March 17, 2017

I would like to go on record stating that the C&H Hog Farm draft permit 5264-W was improperly approved by ADEQ and should be denied. The information I am including in my comments, I feel are relevant to this permit process. It includes historical and current information about storage and land application of liquid waste from this swine facility.

**“PUBLIC NOTICE OF DRAFT NO-DISCHARGE PERMIT  
PERMIT NUMBER 5264-W  
AFIN 51-00164**

# Side by side comparison of select sheets from the NOI and the "As Built" Engineering Plans

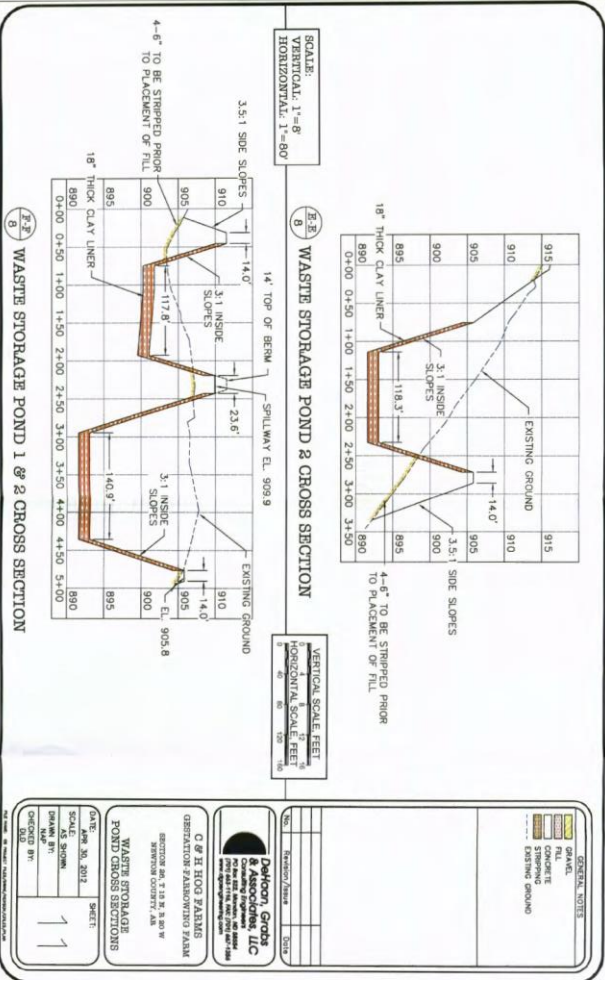
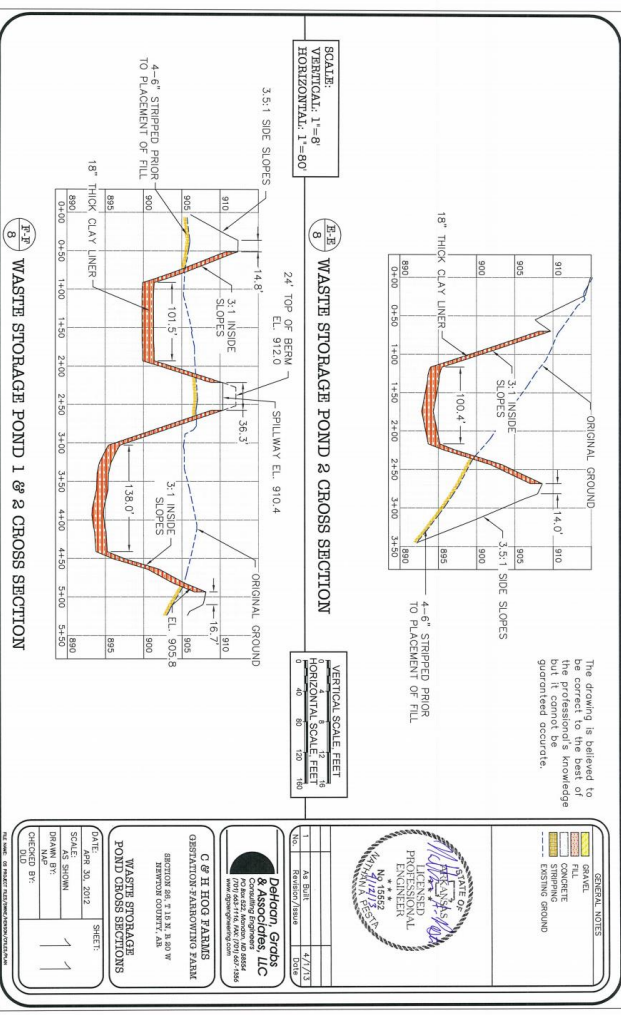
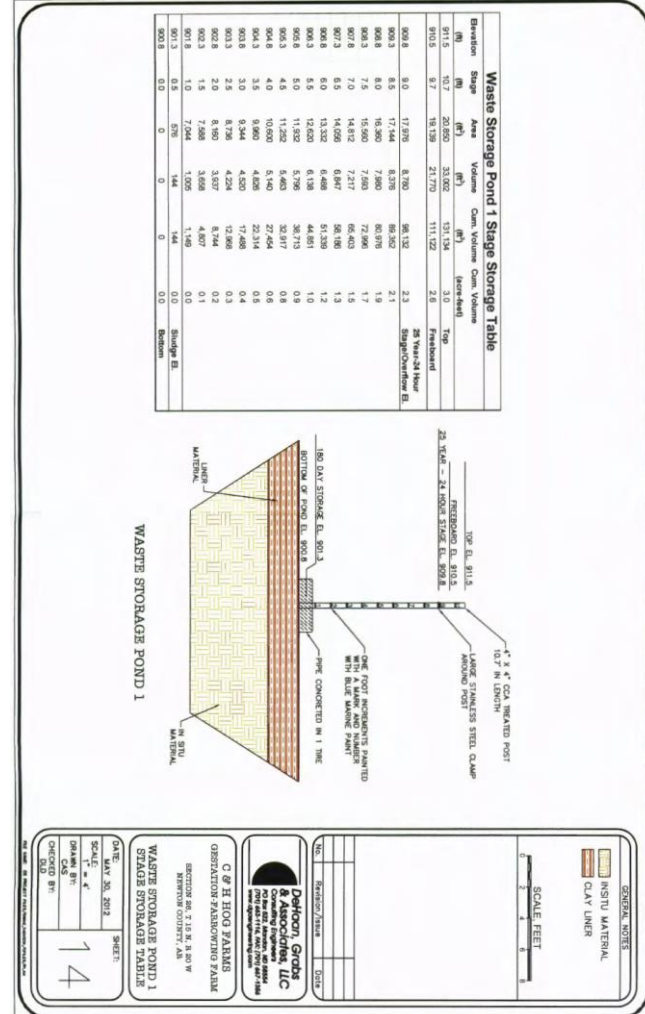
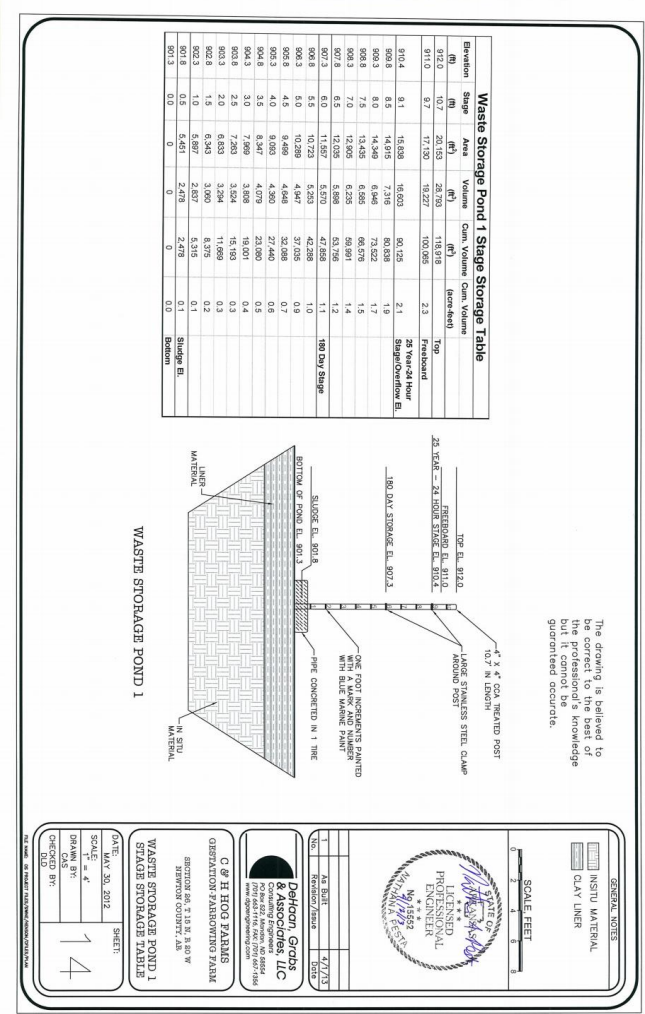
**Have these drawings and documentation been reviewed and determined to be complete by Senior Project Engineer Nathan A. Pesta, P.E. of DeHaan, Grabs & Associates as well as ADEQ? Please respond in detail.**

**Are the documents missing any sheets that are listed on the Cover Sheets (Example: Sheet 15: WASTE STORAGE POND 2 STAGE STORAGE TABLE)? Please respond in detail.**

**Waste Storage Pond 2 Stage Storage Table**

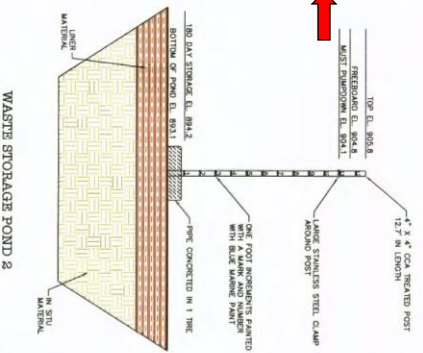
Appears to be **MISSING** sheet 15: **"WASTE STORAGE POND 2 STAGE STORAGE TABLE"**

Important information like:

**"25 Year-24 Hour Stage/ MUST PUMP DOWN"**

**"25 Year-24 Hour Stage Overflow EI."**

Appears to be **MISSING** Sheet 15:

"WASTE STORAGE POND 2 STAGE STORAGE TABLE"

"25 Year-24 Hour Stage/Must Pump Down"

"25 Year-24 Hour Stage Overflow El."

**PROPOSED SITE PLAN**

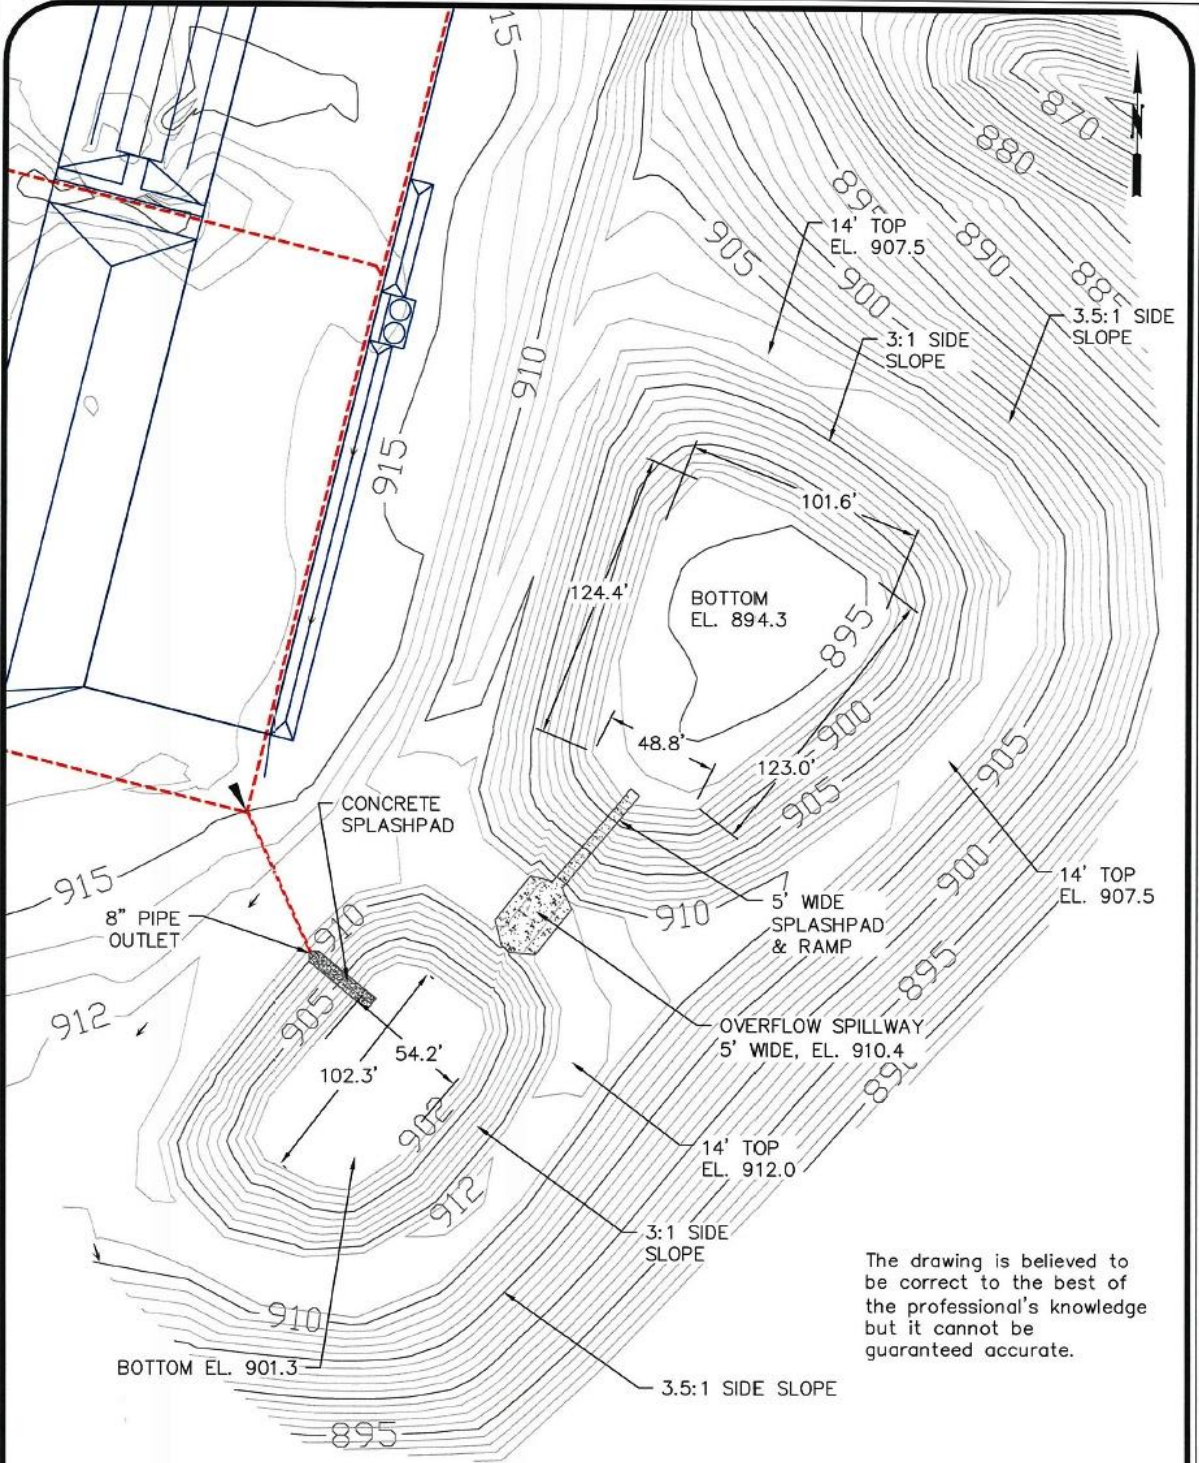
Various Engineering Drawings, some with the State Seal. These are references. References like the NOI Bench Marks, the red dots were added to help define location. I cut the legend that was turned vertically in the drawing to make it easier to read those elevations. (TBM1= 925.68', TBM3=914.71').

Reference Points the engineers used to plan this facility, reference points for the only other boreholes to aid in review of the lithology. These appear to be lower in elevation than the State of Arkansas Certified "Surveyed Boring Location" of 930.61' ?

**BARN CROSS SECTION**

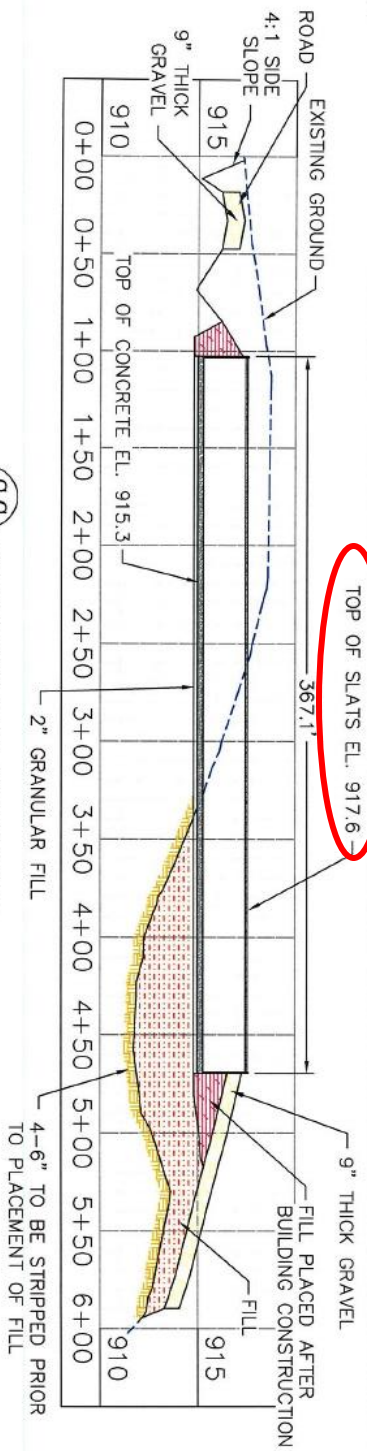
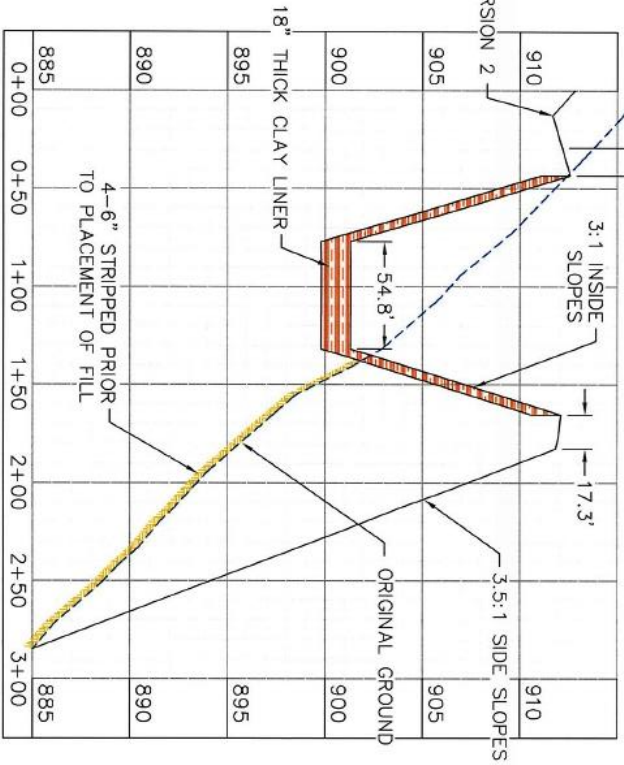
**Elevation for the Barn Slatted Floor = 917'**

Included are Engineering Drawings from the NOI as well as the "As Built" drawings. Sheet 10 below shows "Top of Slats El. 917.6" for the barn. ★ "The Surveyed Boring Location" appears to be 10 to 15' higher in elevation than any elevations recorded on the Engineering Drawing(s) provided below.
